From:	Michal Gaverník
Sent:	17/02/2022 2:17:32 PM
То:	Council Northernbeaches Mailbox; Nick Keeler
Subject:	DA2021/2636 - 9 South Creek Rd, Dee Why, 2099 NSW - Objections to development application
Attachments:	Objection to DA2021-2636 - 9 South Creek Rd, Dee Why, 2099 NSW.pdf;

As per the recent submission for an extension for comments/concerns to the proposed development on **9 South Creek Rd, Dee Why, 2099 NSW - DA2021/2636** we would like to submit multiple concerns to the submitted plans/documents.

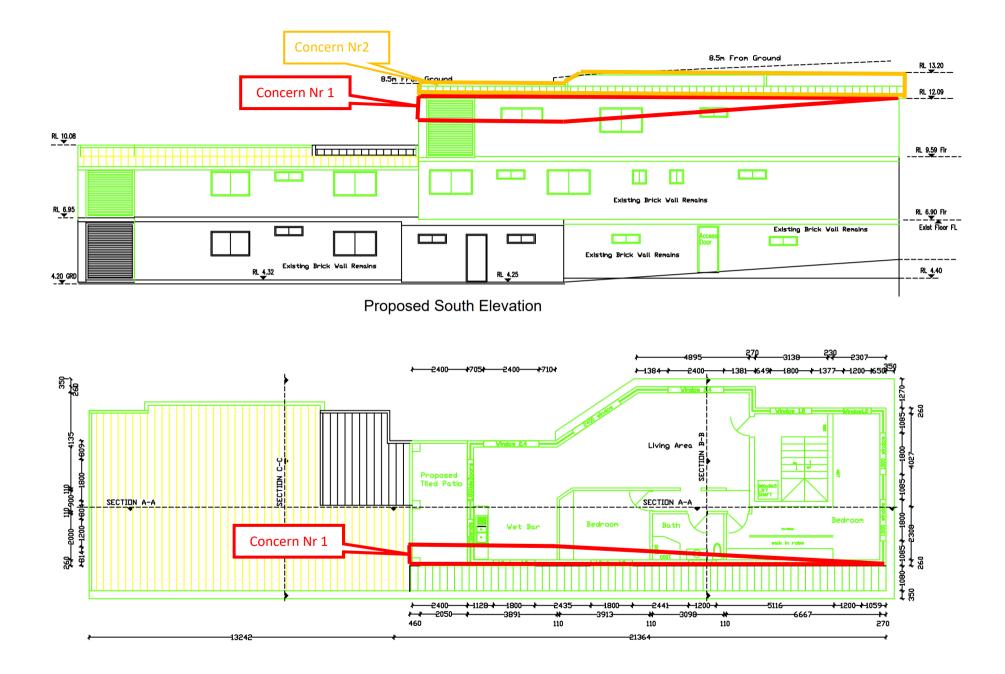
Concern nr.1 <marked as red on plans> (High severity)

As per supplied drawing plans, we believe, that the proposed development **does not comply** with the building code for low-density residential development. In the master plan is shown, that front of building facing South Creek Rd. does comply with Code however as the slope of the land decline from street the proposed building breach boundaries and become **non-compliant**. Please refer to marking on the provided plans

## Concern nr.2<marked as orange on plans> (Medium severity)

There is an unnecessary added rise at the edge of the roof which will provide additional shade to our neighbouring properties (7 South Creek Rd, and 7A South Creek Rd) during the wintertime of the year. Please reconsider the smaller height for the edge of the roof. This way the shading of the properties will decrease.

Proposed East Elevation

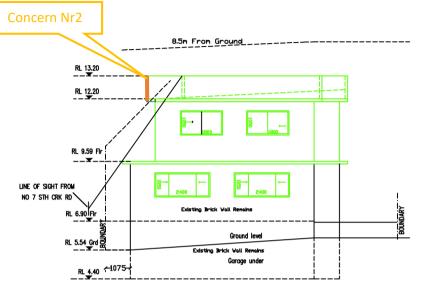
As per supplied documentations, stated in objective of controls we believe, that the proposed development **does not minimise** the visual impact. We do not believe that the proposed 2 and 3 storey development with terrasse on roof complies with the control on the basis that the first-floor level is only setback the minimum 900mm away from the side boundary and lacks articulation to minimise bulk and scale impacts on neighbouring southern properties (7 and 7A South Creek Rd.). The proposed alterations will visually change the dwelling to unit complex.
